MOORE PUBLIC SCHOOLS -
ASC BOARDROOM and STORM SHELTER BUILDING
Moore Public Schools - Moore, Oklahoma
AGP - Moore, Oklahoma

ADDENDUM NO. 2
November 4, 2026

A201

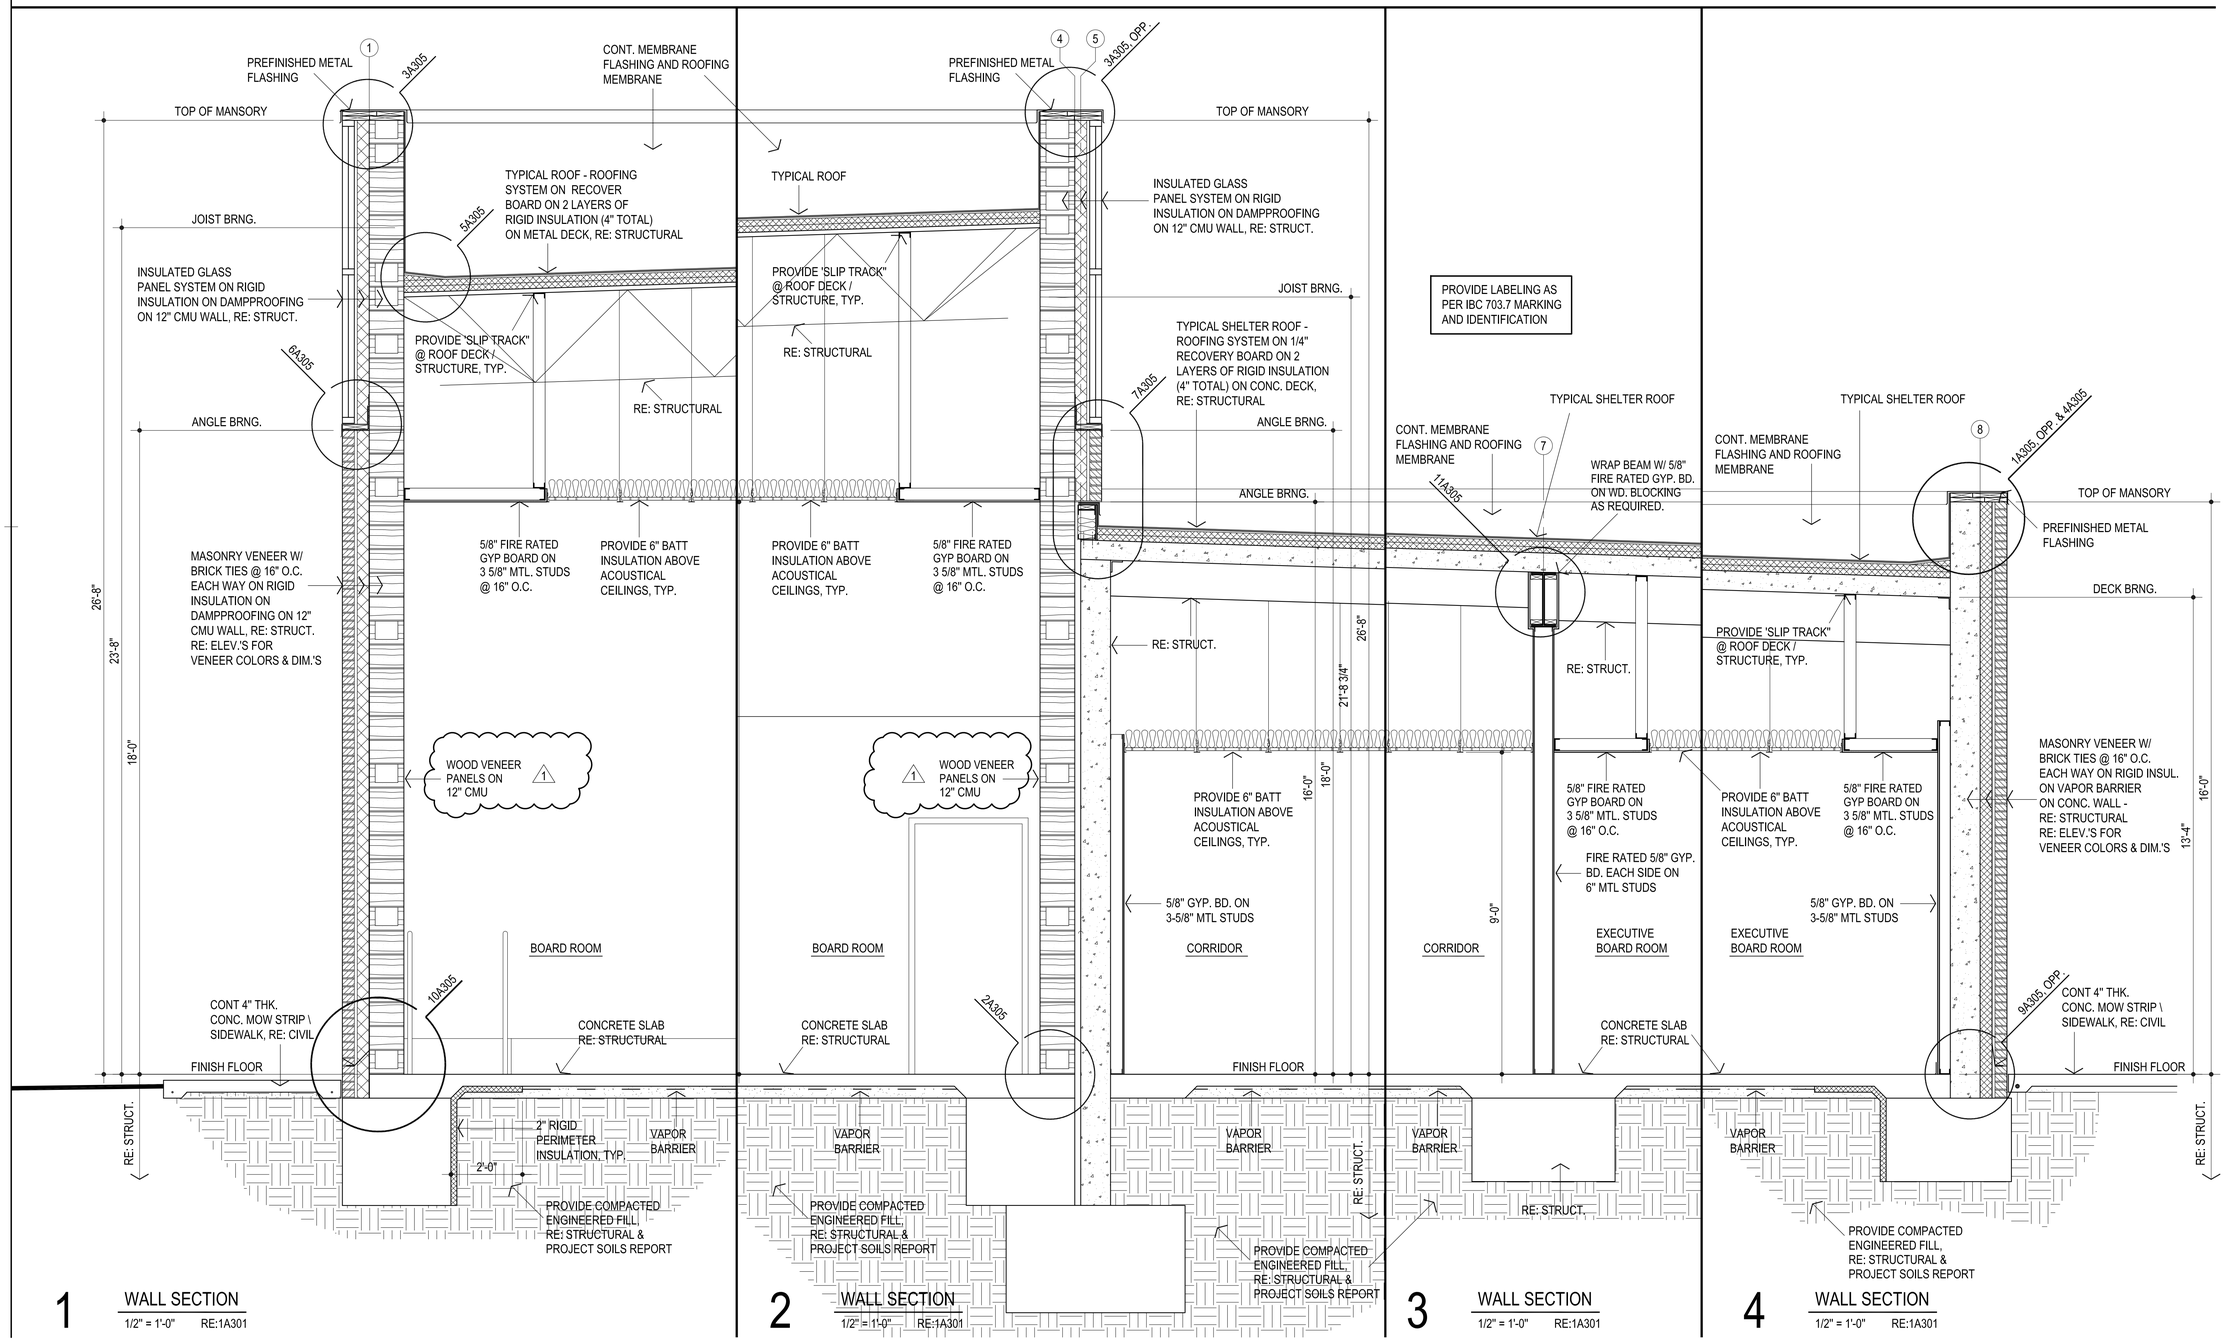
6. Sheet A201, Detail #1, East Elevation: add building identification letters "BUILDING 500" where noted on revised elevation. Refer to new attached replacement drawing.

A302

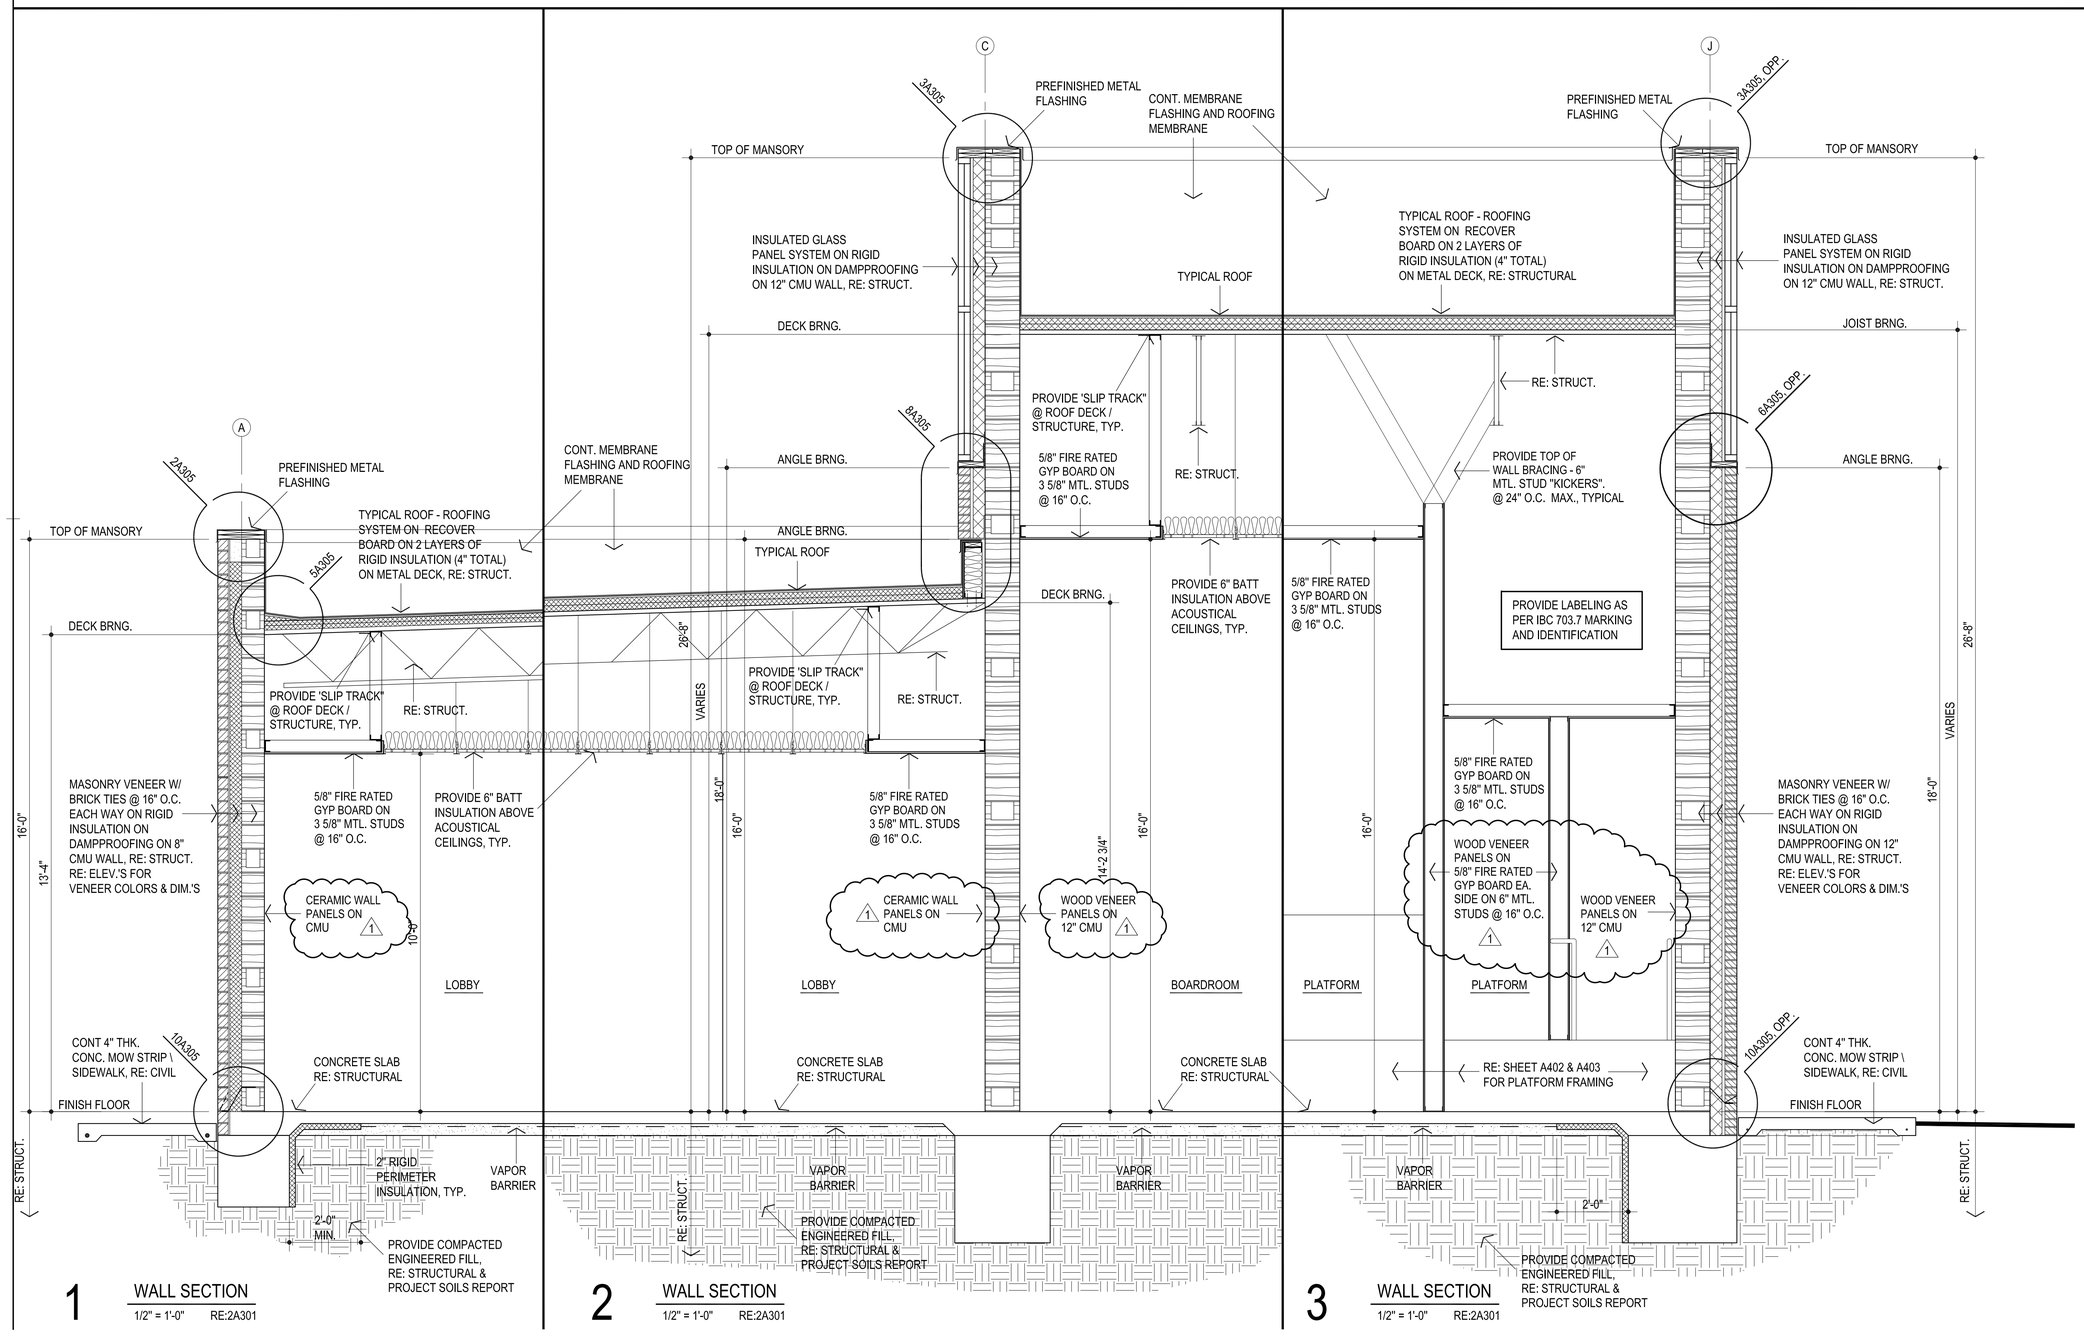
7. Sheet A302, Details # 1 & 2, Wall Sections: added wood veneer panel notes to walls. Refer to new attached replacement drawing.

A303

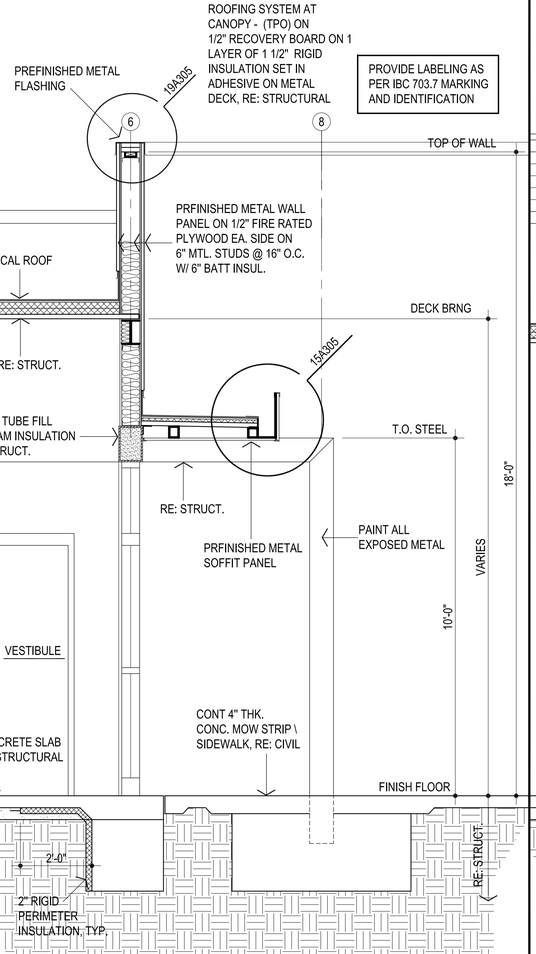
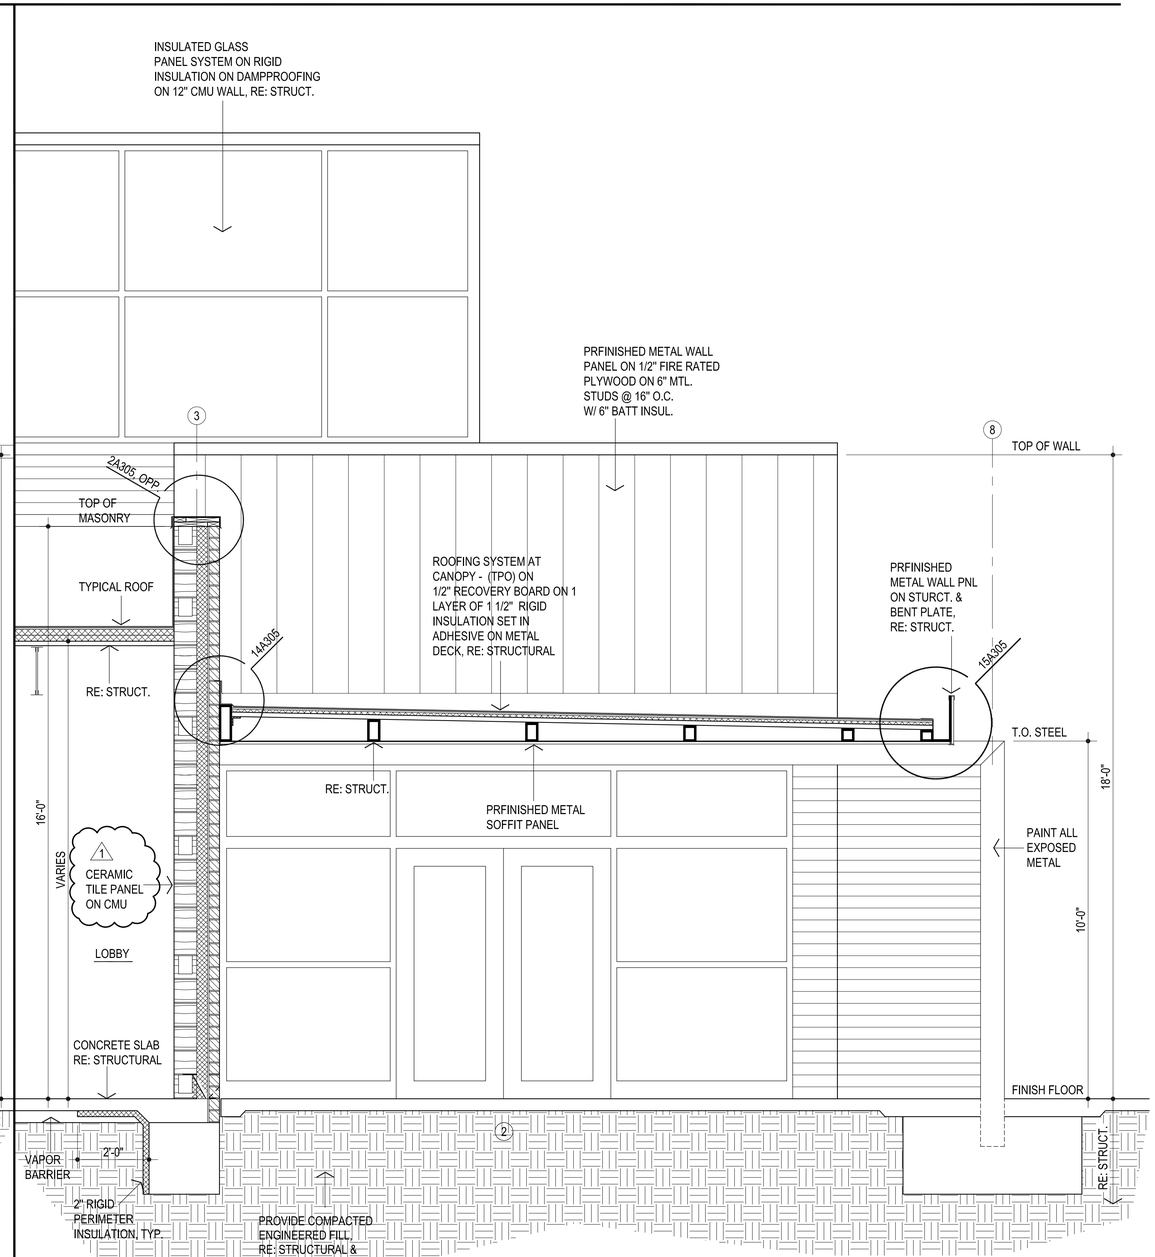
8. Sheet A303, Details # 2 & 3, Wall Sections: added wood veneer panel notes to walls. Refer to new attached replacement drawing.

A402

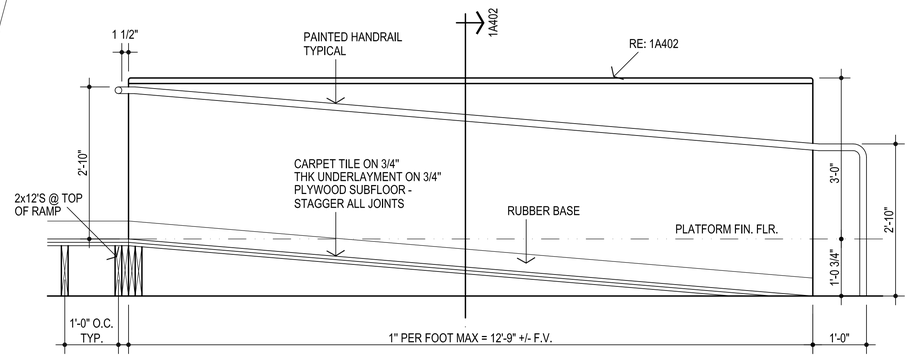
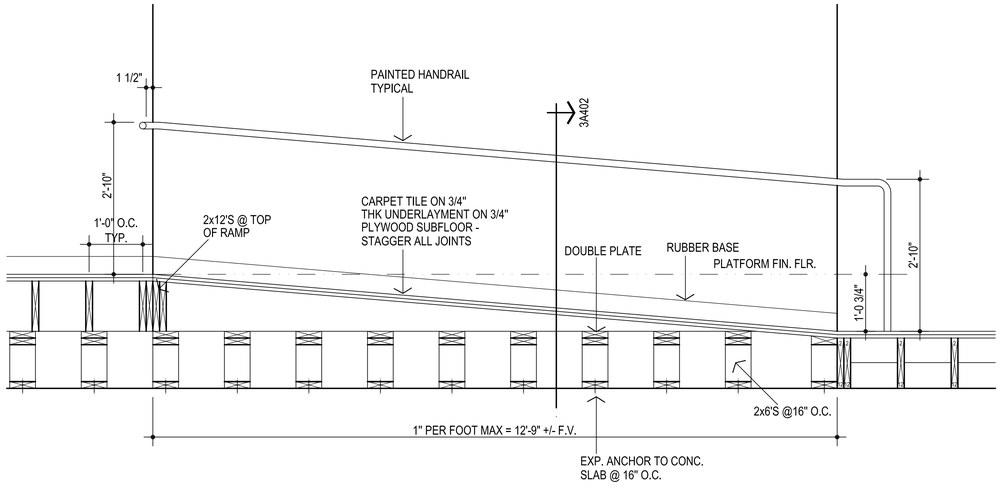
10. Sheet A402, Details #1 & 3, Ramp / Platform Sections: noted wood veneer panels and applicable color. Refer to new attached replacement drawing.

A403

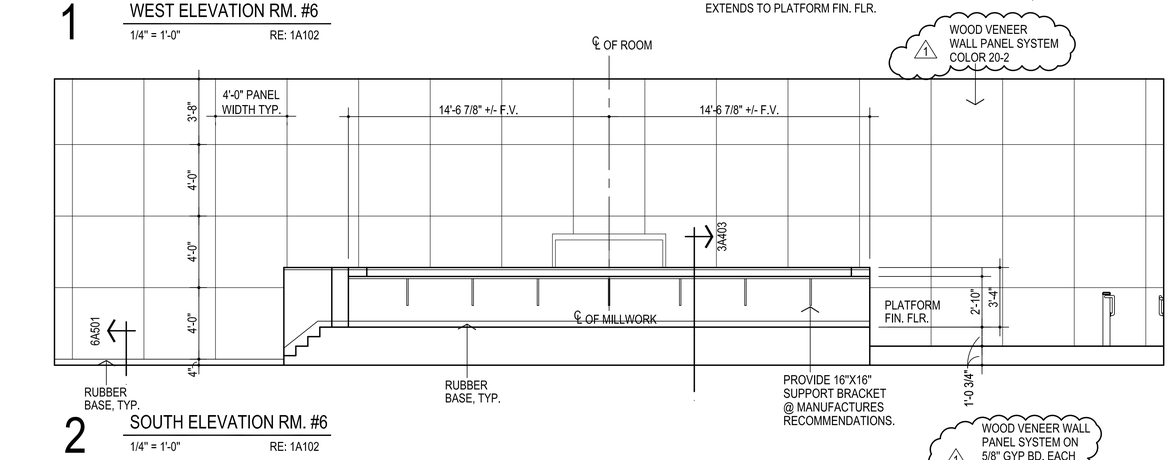
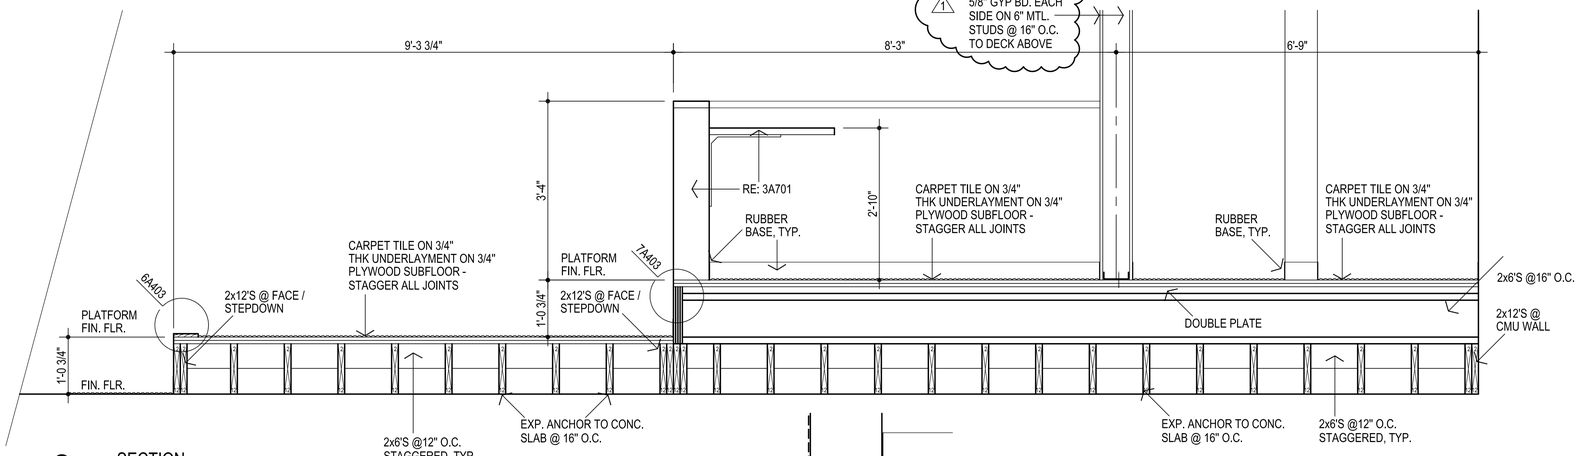
11. Sheet A403, Detail #1, West Elevation Room #6: add precast aluminum letters to curved wall behind board member's counter. Refer to new attached replacement drawing.

12. Sheet A403, Detail #1, West Elevation Room #6 & Detail #2, South Elevation Room #6: noted wood veneer panels and applicable colors. Refer to new attached replacement drawing.

1 SOUTH ELEVATION RM. #5 & 6

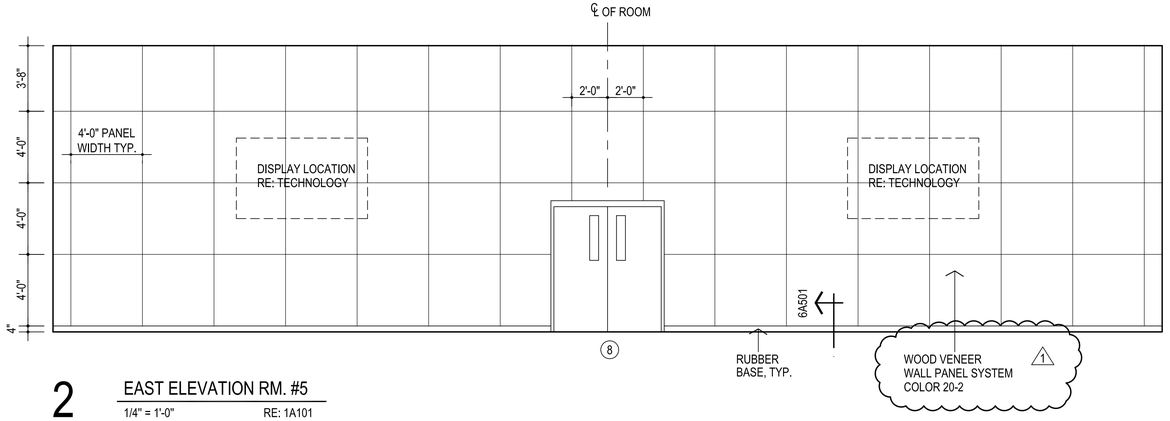
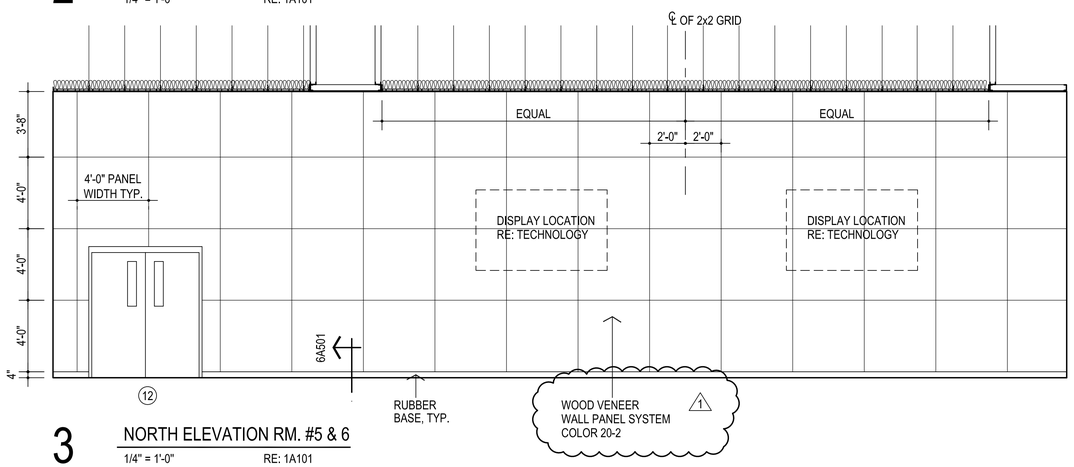
13. Sheet A404, Detail #1, South Elevation Rooms #5 & 6 / Detail #2, East Elevation Rooms #5 & 6 / Detail #3, North Elevation Rooms #5 & 6: noted wood veneer panels and applicable colors. Refer to new attached replacement drawing.

34
1

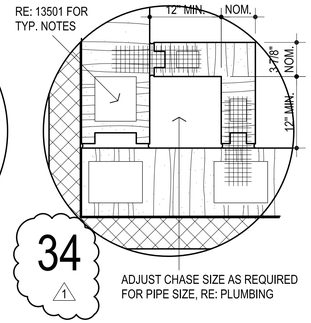
14. Sheet A501, Detail #34, Plan Detail: revised detail. Refer to new attached replacement drawing.
